Recommended Items for 2018

The following are proposed rule changes made by the Club Racing Board. These items will be presented to the Board of Directors for approval at their National Convention meeting. Comments, both for and against, should be sent to the Club Racing Board via <http://www.crbcca.com> or www.clubracingboard.com. The CRB recommendations for implementation of these rule changes, if approved, is noted in each letter. The letter number, Fastrack month, author, and title precede each proposed rule.

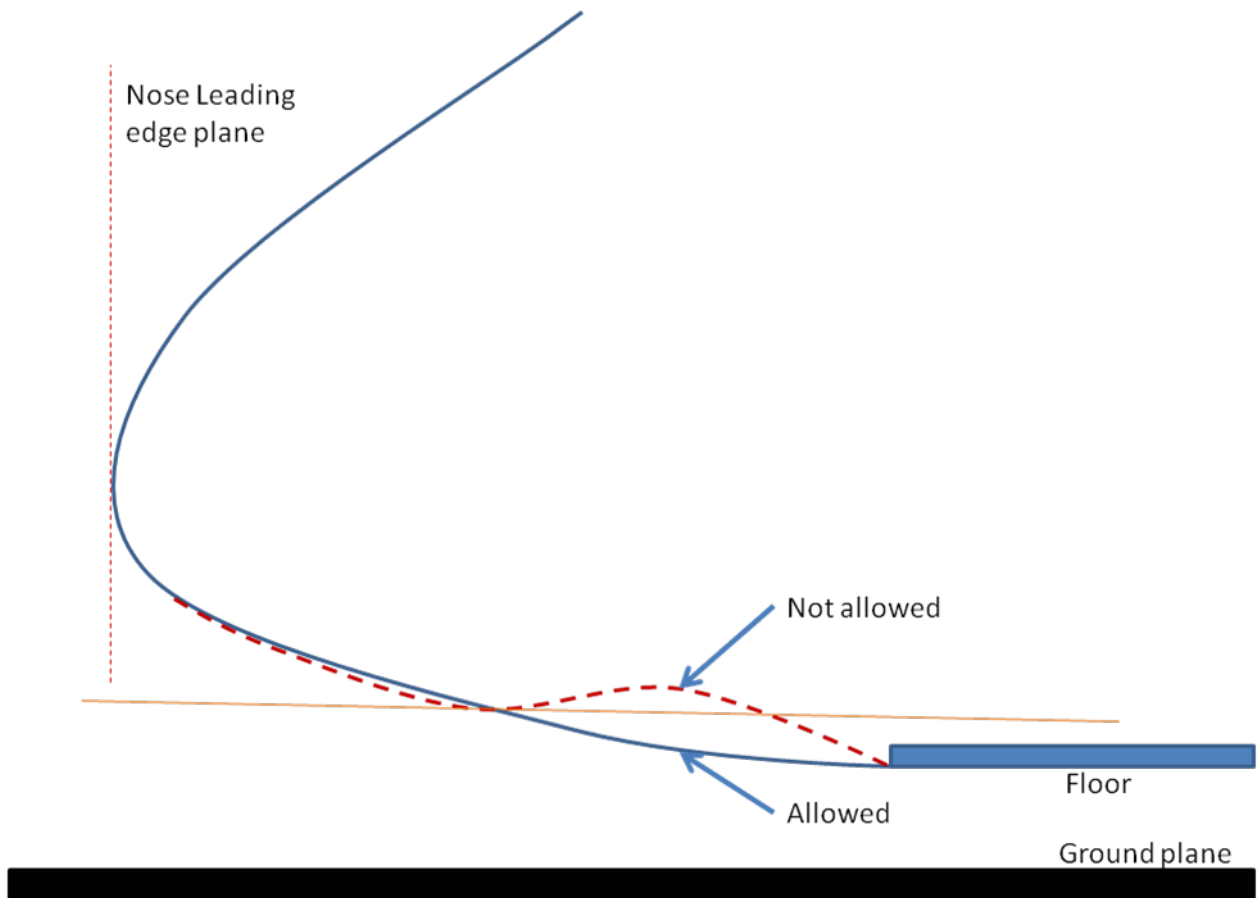
In GCR section 9.1.1.D.9.f., add the following language and illustration: "It is not permitted to duct air through any part of the bodywork for the purpose of providing aerodynamic downforce on the car. It is not permitted to duct any air through the downward facing surface of the nose of the car *extending to the front axle* or through the lower surface of the car between the front and rear axles. *The surface of the nose – facing the ground plane aft of the nose leading edge plane – along its entire length at or before and extending to the level of floor of the car at or forward of the front axle, must be either parallel to or convex, as compared to the ground. (see illustration)*

Illustration of strut housing modification discussed in section g) 4.

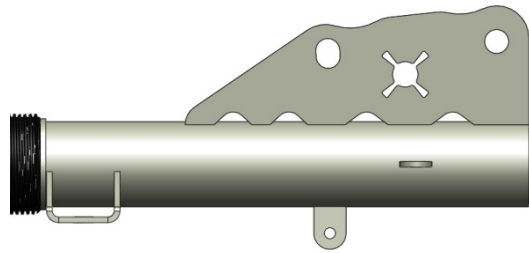
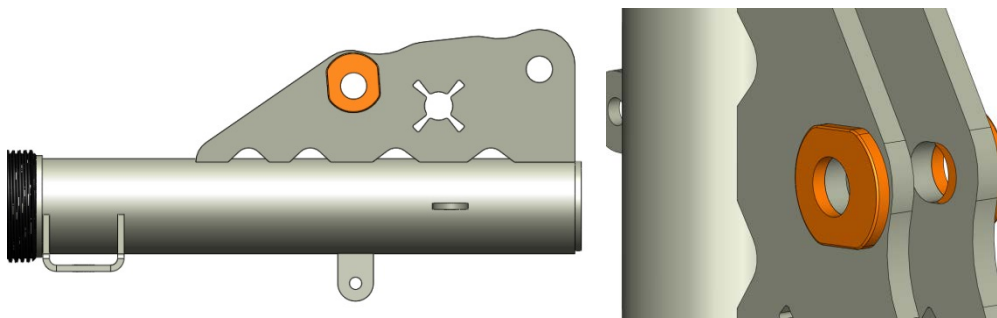
Figure 1: SMG Strut housing with Slotted Upper Hole.
(Note: JRi housings have the slot on the bottom hole)

Figure 2: SMG Strut Housing with Camber Slug Installed.

But this IS the only allowed means to go beyond 3.0 degrees of negative camber. Potential tire clearance issues, resulting from this modification, are addressed in Section o). No machining of body to allow further travel. Caster: min. +6.35; max. +7.85. Camber plate PN MM5CC-5 or CCP197-05-09.
